SERVICE BULLETIN NO. 76

SUBJECT: Instructions for Modifying Ailerons on B17 and C17 Model Airplanes to Remove the Restrictions Imposed by C.A.A. Airworthiness Bulletin No. 26.

AIRPLANES AFFECTED: All B17 and C17 Model Airplanes up to and Including Serial Number 135.

FIGURE NO. 1

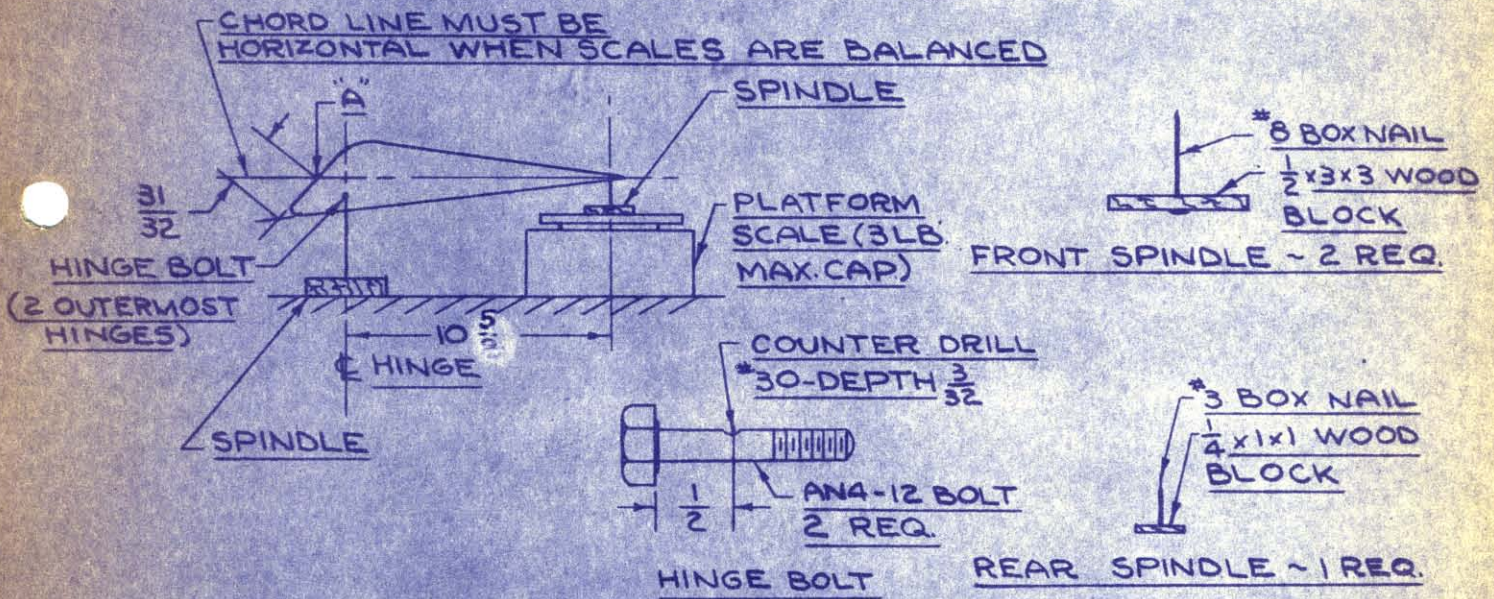
1. Determine the balance condition of the ailerons as they are when removed from the wings (previous to beginning modifications). Record this information on the attached form page No. 5 and return it to the Beech Aircraft Corporation. Be sure to do this as the Civil Aeronautics Authority requires this information. The aileron should be set up as illustrated in Figure No. 1 with the chord line horizontal. The chord

line will be a line drawn through point "A" on the aileron nose bisecting the trailing edge radius on the root rib. The weight registered on the scales will be the amount the aileron is out of balance at this point. If the scales register zero the aileron is balanced. Should the trailing edge tend to rise the aileron is over balanced.

FIGURE NO. 2

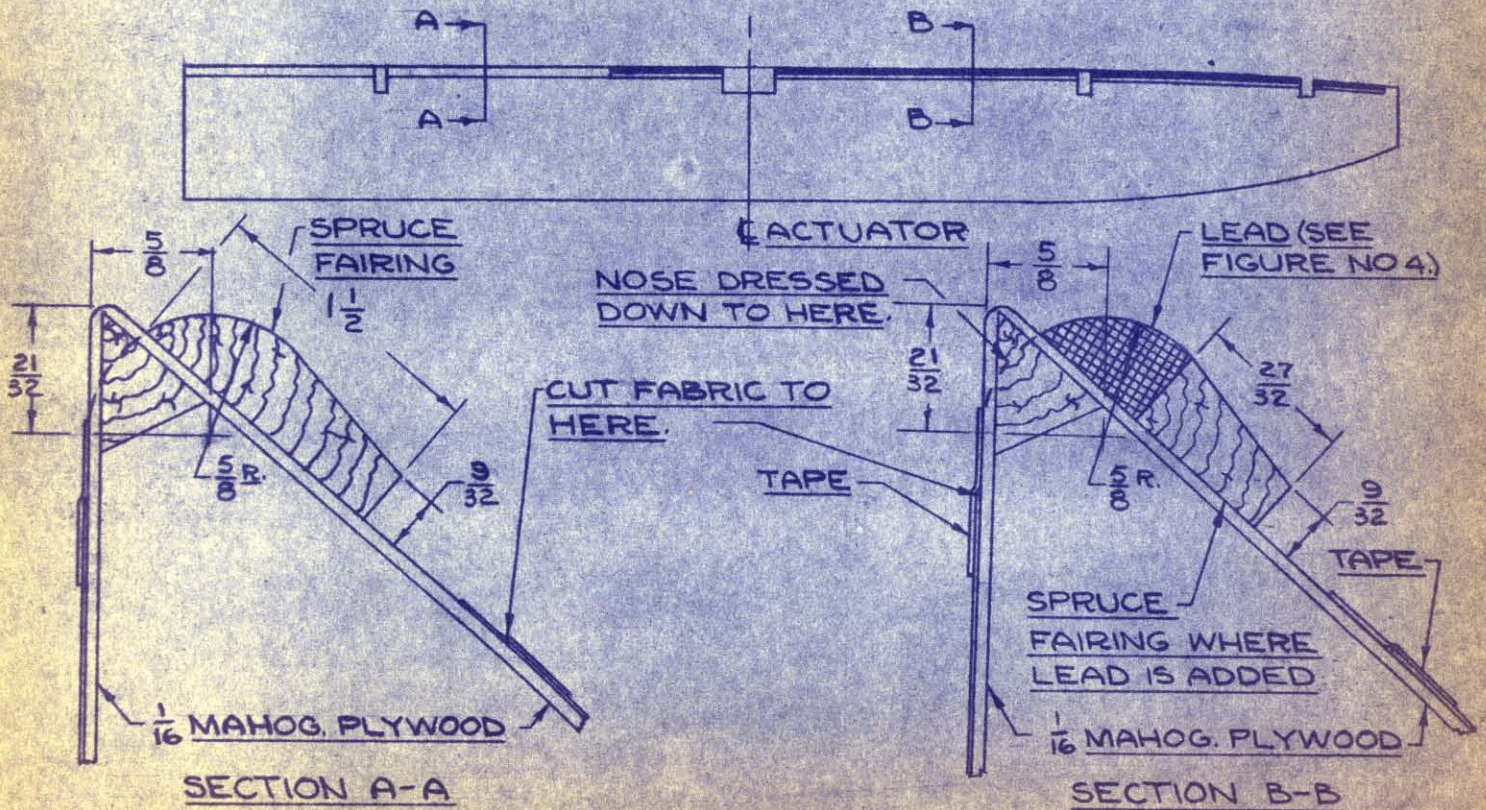
4. Glue wood fairing strips to leading edge, locating as illustrated in Figures 2 and 4. Nail fairing strips to ribs to keep fairing from sliding while gluing pressure is being applied. Apply gluing pressure by piling sand

FIGURE NO. 3

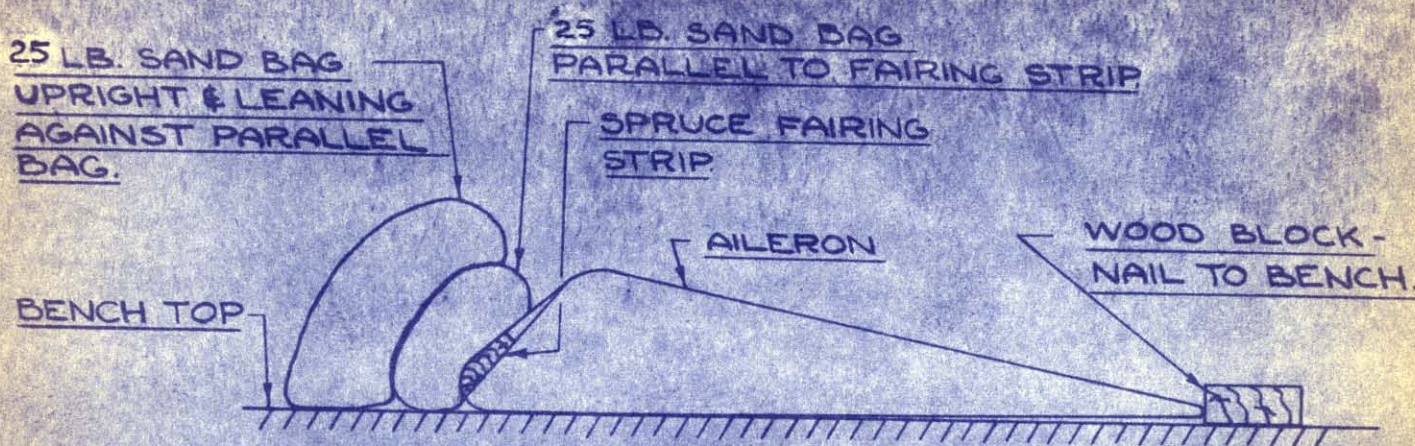
bags against aileron nose as in Figure No. 3.

FIGURE NO. 4

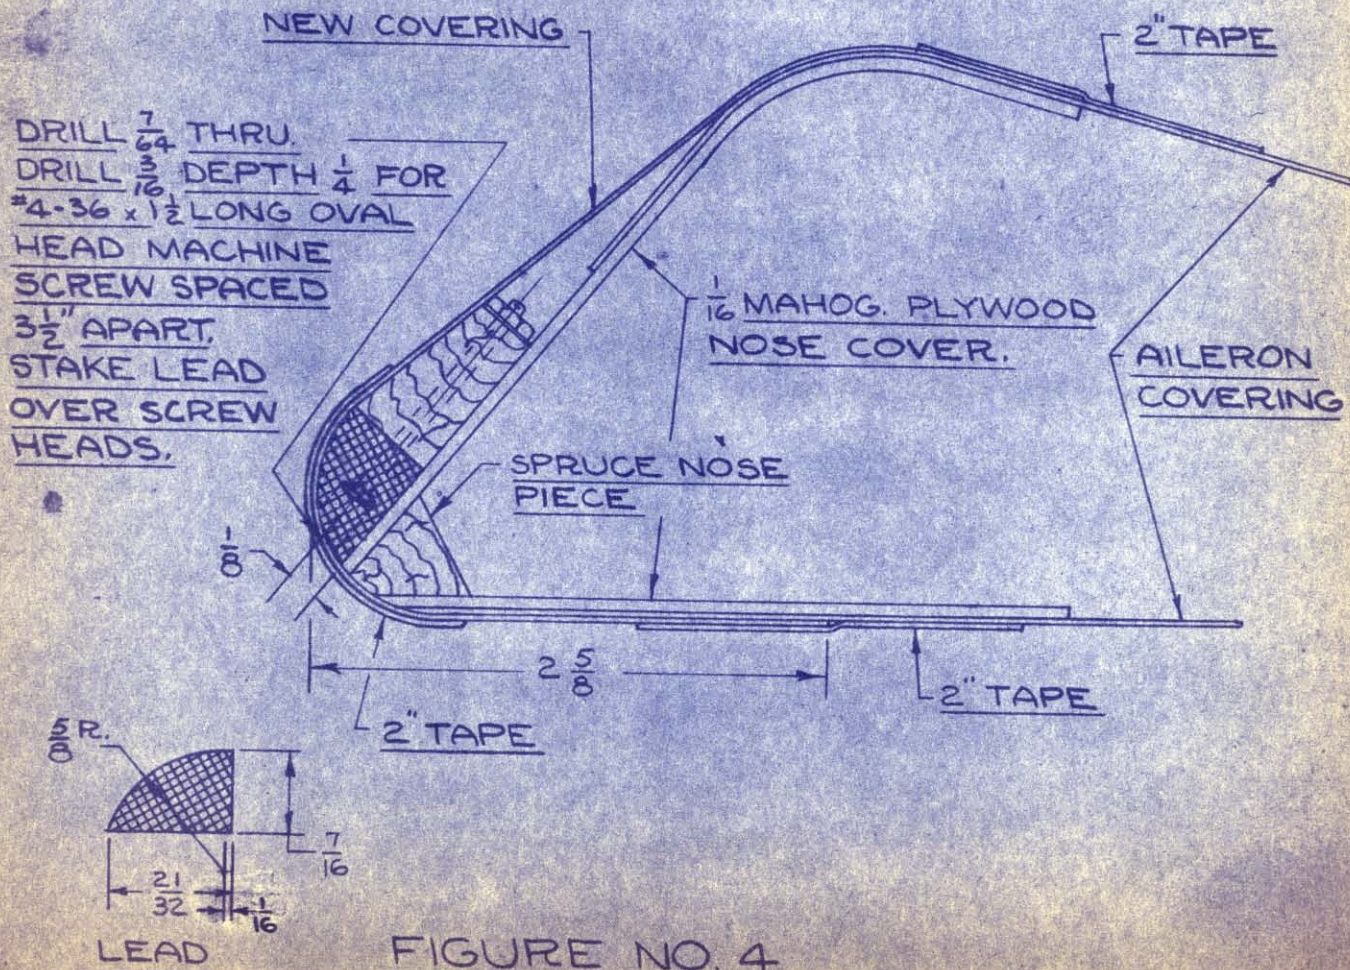
2. After the balancing condition has been determined, prepare nose section for the addition of a new lead section and a wood fairing strip for the purpose of rounding the nose and balancing the aileron (See Figure No. 4). To do this proceed as follows:

- (a) Clean aileron with compound.
 - (b) Sand back on both sides of aileron for fabric to be added later over the reworked nose. See Figure No. 4.
 - (c) Cut fabric along aileron nose one inch back on underneath side and two and one-quarter inches up on top side. Tape remaining fabric to plywood to prevent shavings from getting in between fabric and plywood.

5. Attach lead to glued on wood fairing strip with #4-36 1-1/2 long oval head machine screws, spacing 3-1/2 apart. See Figure No. 4.
